20 June 2019

# DEXUS QUARRYWEST PROJECT (SSD 6801) - SECTION 4.55 MODIFICATION (MOD 9) - STATEMENT OF ENVIRONMENTAL EFFECTS

Figure 6: Precinct F Site Plan – As Proposed (Source: Nettleton Tribe)

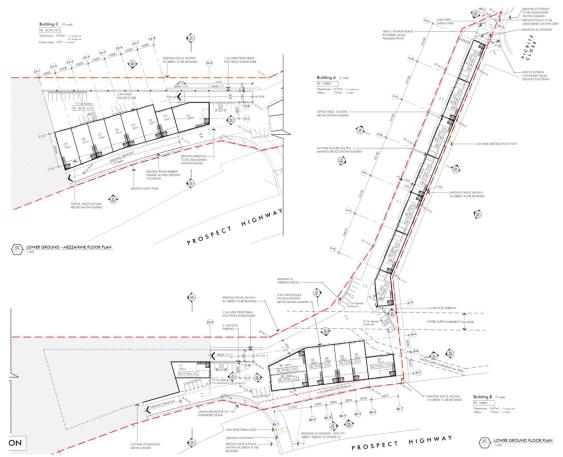
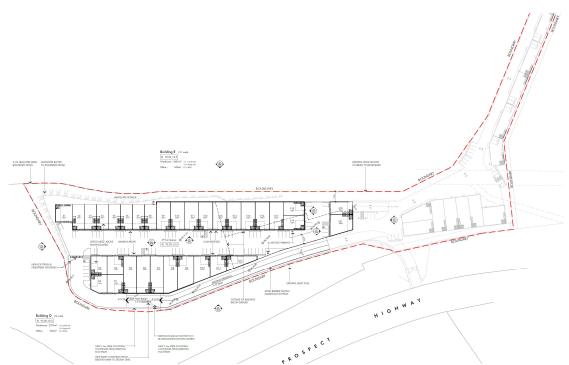
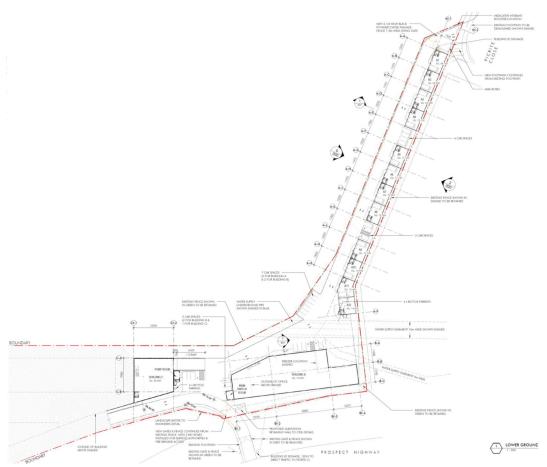
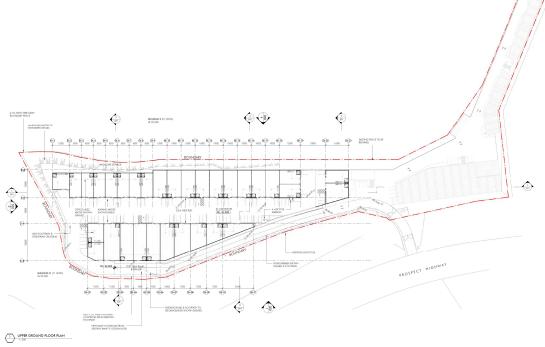
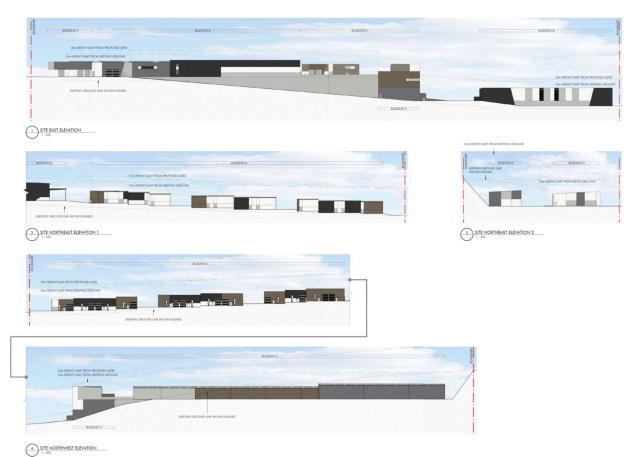
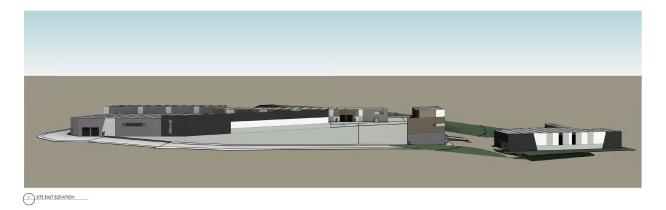
Hannas proposes to modify the development consent for the QuarryWEST Project to amend the internal masterplan layout in Precinct F, including:

- altering the size and layout of Building A, including:
  - o breaking up the building into 3 detached buildings;
  - o reducing the size of the tenancy units, and increasing the number of units from 7 to 12: and
  - reducing the overall size of the building;
- consolidating Building B into a single tenancy unit, from the 7 approved units;
- removing the majority of Building C, including the upper mezzanine level;
- minor changes to some building materials and layout, and changes to internal circulation and parking; and
- reducing the amount of excavation, which would raise the pad level by approximately 0.5m, but not increase the maximum building RL (which had a ±0.5m tolerance on the approved plans).

Figure 12: Stormwater Catchment Plan (Source: Costin Roe)

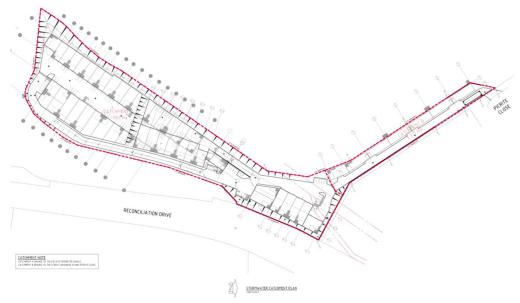
Xavier Knight has prepared an updated stormwater concept plan for the proposed modification, and reviewed the plan against the approved stormwater system (see **Appendix C**). Whilst splitting Catchment A into two sub-catchments (and renaming Catchment B to Catchment C), the review confirms that the updated stormwater plan for Precinct F is similar to the plan approved under MOD 6, and is consistent with the stormwater management planning for the wider estate. It is noted that the proposed modification would not result in any change to the impervious area of the site.
